**Edwin I. Hatch Nuclear Plant
Request to Implement an Alternative Source Term
Response to Request for Additional Information Regarding the
Turbine Building Ventilation and Leakage Treatment Piping Seismic Evaluations**

**Response to Request for Additional Information Regarding the Turbine
Building Ventilation and Leakage Treatment Piping Seismic Evaluations**

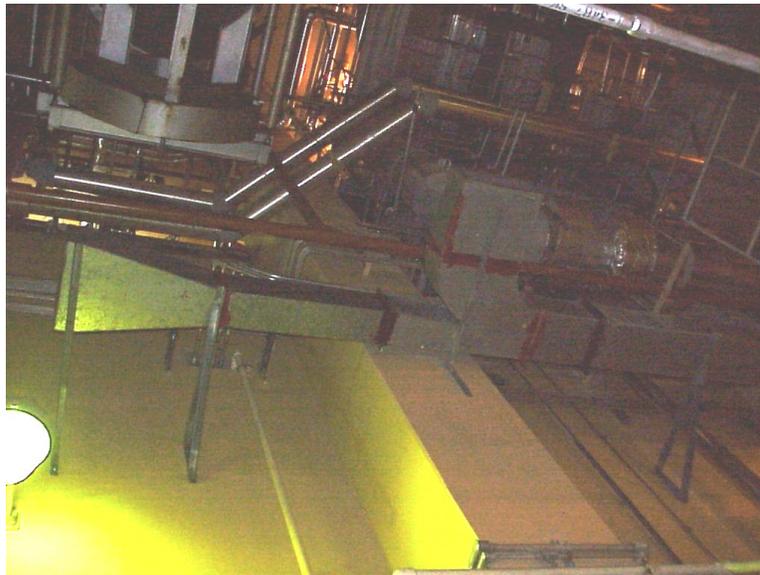
This RAI is in reference to duct support analytical review outlier AR-1, discussed in Enclosure 11. This support was an outlier of the Vertical Capacity Check at 5 times the dead load. Per the EPRI guidelines, the Lateral and Longitudinal Load Check may be used to evaluate outliers that do not meet the Vertical Capacity Check. This is most applicable to supports characterized as non-ductile. From review of the support drawing shown on page B-4 of Enclosure 11, this support appears to be non-ductile. The bottom and particularly the top welds appear to be weaker than the support vertical members and a plastic hinge may not be formed in the vertical member(s) preventing possible weld failure by allowing ductile response. As stated in the EPRI report, a brittle failure (weld failure) is not acceptable seismic performance. Page E-2 of Enclosure 11 states that this support was evaluated for both lateral and longitudinal seismic loading and was found adequate. From the support drawing shown on page B-4 of Enclosure 11, the vertical support members are skewed to the top and bottom welds. The all around 1/8-inch fillet weld designation on the bottom weld is considered a weak weld. In addition, due to its skewed orientation, the effective weld throat is less than 0.707×0.125 on the longitudinal direction side of the angle iron which compounds its ineffectiveness. The top weld is a flash (fill) weld and by common engineering practice is not considered to provide resistance to structural loads, seismic horizontal plus dead load in this case.

- (a) For the "Lateral Load Check" EPRI recommends using a horizontal static equivalent seismic input of 1.0 times the PSA of the IRS at 5% damping. Figure 3-1, Enclosures 11 and 12, indicates this value to be approximately 0.32. If a different value was used provide technical justification.
- (b) Provide technical justification regarding the structural adequacy of these welds to support the design loading. Also, provide the size of the vertical members (size is not shown on support drawing).

- (a) The EPRI guidelines recommend using the PSA of the IRS unless the frequency of the duct-support system is calculated. For this support, the PSA was quite high, so the duct-support system frequency was calculated. The combined lateral frequency of the duct and supports was found to be 19 Hz. The spectral acceleration of the IRS for the turbine building El. 209' at 19 Hz is 0.20g. This is the acceleration that was used for the lateral load check.
- (b) The vertical members are $1\frac{1}{2} \times 1\frac{1}{2} \times \frac{1}{8}$ " angles. The welds at the ends of the angles are of two types. At the duct end, the weld is a full penetration square-groove butt weld. These welds were visually inspected by the SRT. They appeared to be of good quality and joined the adjacent pieces through the full thickness. This type of weld is an allowable American

With reference to the support drawing on Page B-4 of AST submittal Enclosure 11, the following clarifies the configuration of the angle at the point of attachment to the wall based on updated information. The support angle leg has an extension welded on with a square-groove butt weld. This extension piece is fillet welded to the vertical leg of the embedded angle on the top corner of the concrete wall. At the wall attachment, the weld consists of two ½” vertical fillet welds, one on each side of the vertical leg of the support angle. Each weld is approximately 2” long.

The following photographs show the support configuration, looking up at the weld to the embedded wall corner angle.

The weld capacity was not evaluated for the lateral load check (it was judged to be adequate, so only the angle section was evaluated). The following provides an evaluation of the fillet-welded connection for the lateral and longitudinal loads. The resultant forces (seismic demand due to dead load plus seismic loads) on the weld are 368 lb/in for the lateral load check and 164 lb/in for the longitudinal load check. The weld electrode is taken as E60XX. The weld seismic capacity is 1.7 times 0.3 times the weld metal tensile strength from AISC 9th Edition Table J2.5 (this is the same weld capacity recommended in Section C.6.1 of the SQUG GIP Revision 2). The capacity of the 1/8" fillet weld is $1.7 \times 0.3 \times 60,000 \text{ psi} \times 0.707 \times 0.125 \text{ in} = 2704 \text{ lb/in}$. The seismic capacity of the weld is seen to be greater than the seismic demand for the lateral and the longitudinal loads. This confirms the original judgment.

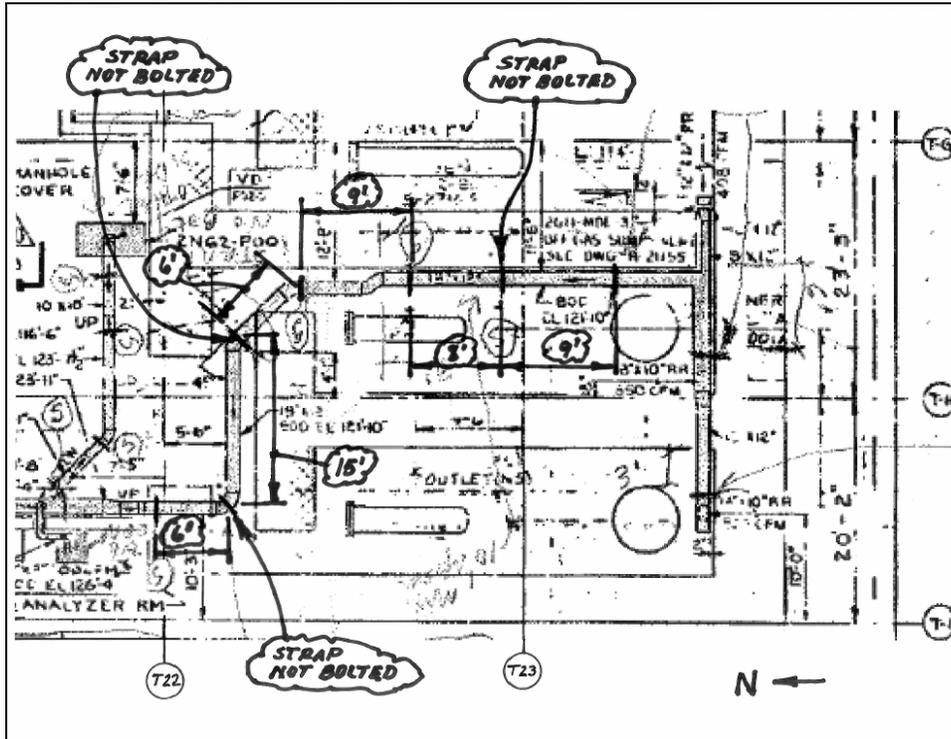
Unit 2 walkdown outlier No. 7 involves 3 duct strap hangers on a duct run that is not connected to overhead structural members. At least two of these appear to be adjacent to each other. Confirm whether this is correct. If missing supports are not adjacent to each other, ignore the remainder of this RAI. The affected duct run (19x12) appears to have changes in direction (at least two) between supports adjacent to these unconnected straps. It was judged that the duct runs containing these three hangers were acceptable as adequately supported without these strap hangers.

- (a) Provide a line sketch with approximate support span dimensions that shows the duct run containing these 3 strap hangers and 2 functional adjacent hangers on each side of the run containing a missing hanger (existing walkdown information and drawings could be utilized).
- (b) Related to item 14.a above, provide the allowable duct spans and any span associated data, such as span stresses and loads, to confirm that existing spans without the three nonfunctional supports still meet allowable span criteria. Discuss whether you included reduction factors for changes in direction. Also provide your technical justification if reduction factors were not included in your evaluation.
- (c) Provide the load rating for this type of strap hanger and compare it to the approximate loading of the straps adjacent to the nonfunctional supports.

It is correct that two of the un-attached strap hangers are at adjacent support points. See the response to Question 14b below for justification of the existing condition observed during the walkdowns.

- (a) The approximate support span dimensions for the duct run containing the un-attached strap hangers are shown on the following mark-up of the original walkdown drawing. Two of the hangers are adjacent and the span between them is 15 feet. The other hanger is between two hangers that are properly attached, and the span is 8 feet on one side and 9 feet on the other. It should be noted that at this location and at one of the other locations, only one strap on the duct is not attached to the ceiling. The strap on the other side is properly attached to the ceiling and is directly attached to the duct. It has sufficient capacity to support the duct by itself, and the unattached strap was accepted on this basis.
